KIRK® Release Notes
KIRK® 6020, KIRK® 6040
KIRK® 7010, KIRK® 7020 and KIRK® 7040

Firmware Version PCS 07Pa
Q2, 2011

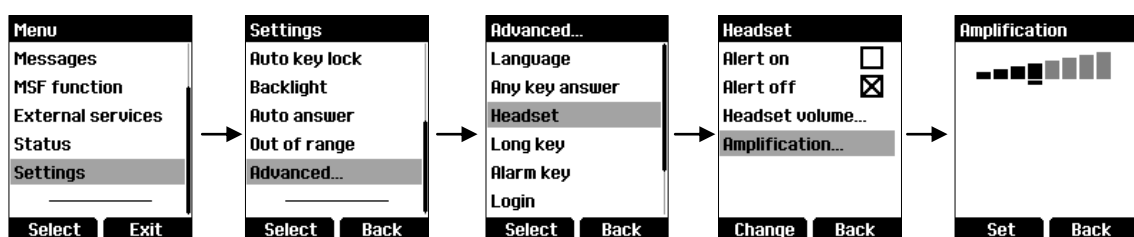
- Start date in *Menu/Settings/Advanced/Time & date*, has been changed to 1/1-2011.

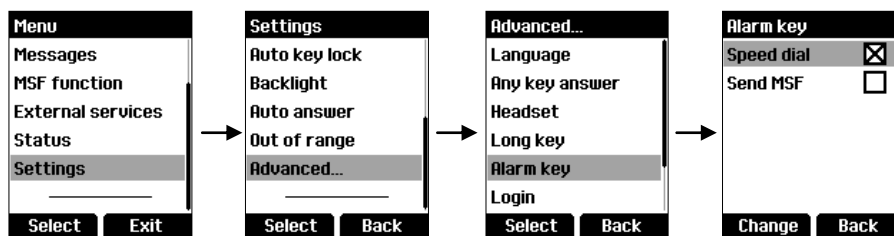
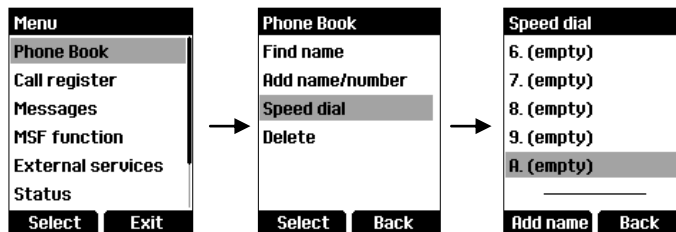
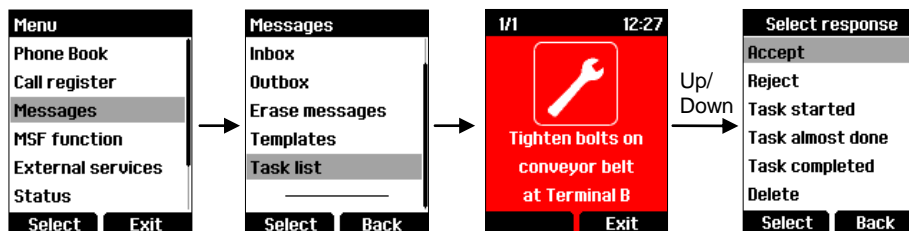
- An entry in the phone book can be assigned to a long key press on the alarm key. First the alarm key must be configured to use speed dial, see below.

Then speed dial entry “A” must be assigned by selecting Add name:
